# TECHNICAL SERVICE BULLETIN

## Single Rear Wheel Only - Boom/Hum/Moan Noise Or Vibration From Rear While Driving At Highway Speeds

**22-2043**

<b>Ford</b> 2015-2021 Transit	Single Rear Wheel Only (Does Not Apply To Dual Rear Wheel Vehicles)
----------------------------------	---

Figure 1

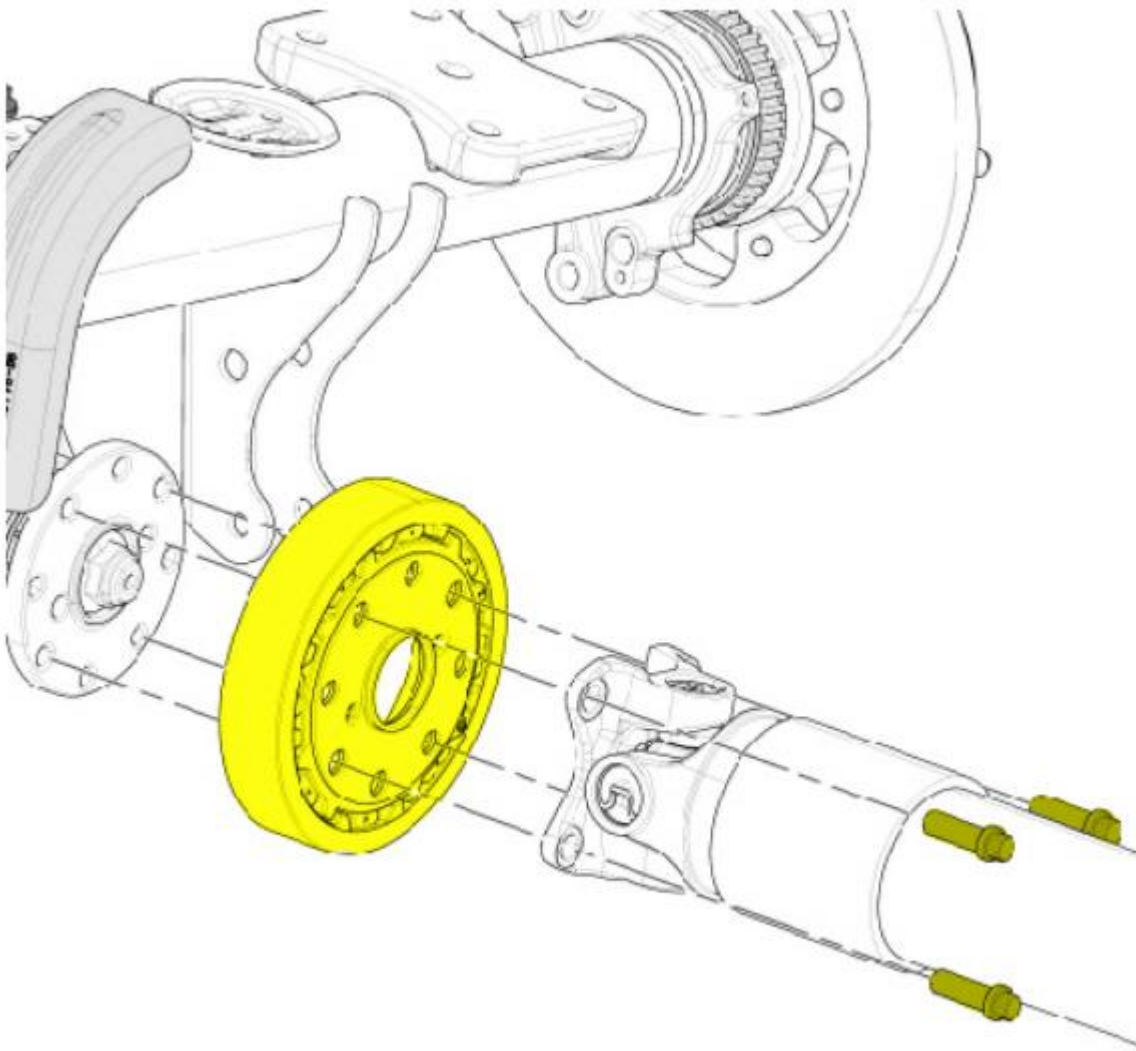
6. Inspect the pinion flange to driveshaft mating surface for any debris or excessive rust and clean as necessary.
7. Install the driveshaft torsional damper on the axle pinion flange. (Figure 1)

**8.** Align the index mark on the driveshaft and rear drive pinion flange and reinstall the driveshaft. Make sure the driveshaft fits securely over the raised flange on the torsional damper.

(1). Install the driveshaft attaching bolts and tighten to 115 Nm (85 lb-ft) Refer to WSM, Section 205-01. (Figure 1)

Figure 2

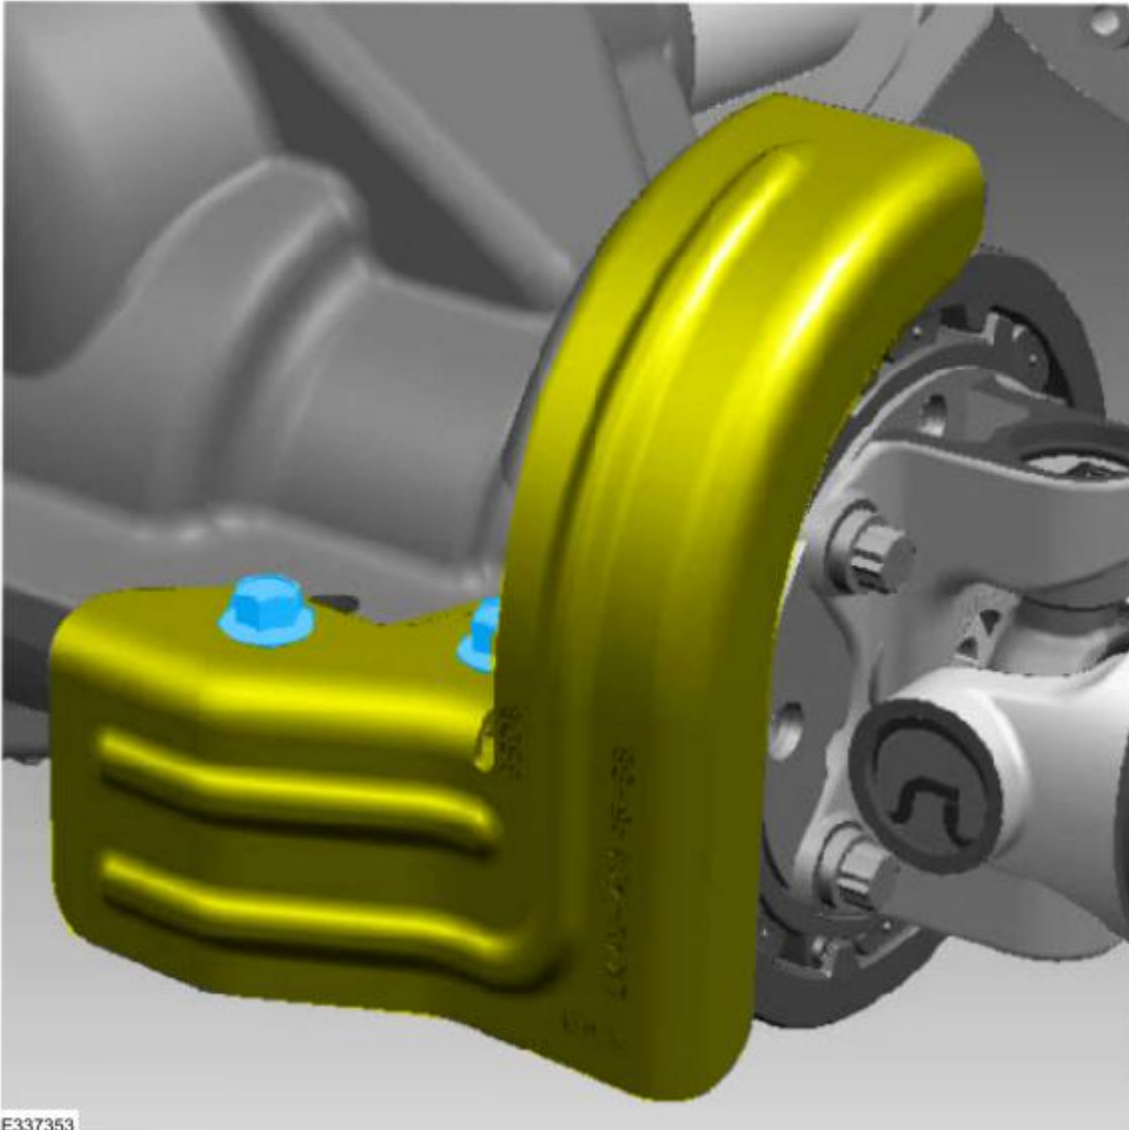
**9.** Using the existing holes in the axle housing, install the torsion damper shield to the right side of the axle assembly near the pinion. Install the 2 bolts and the nut supplied in the torsional damper kit. Tighten to 48 Nm (35 lb-ft). (Figure 2)
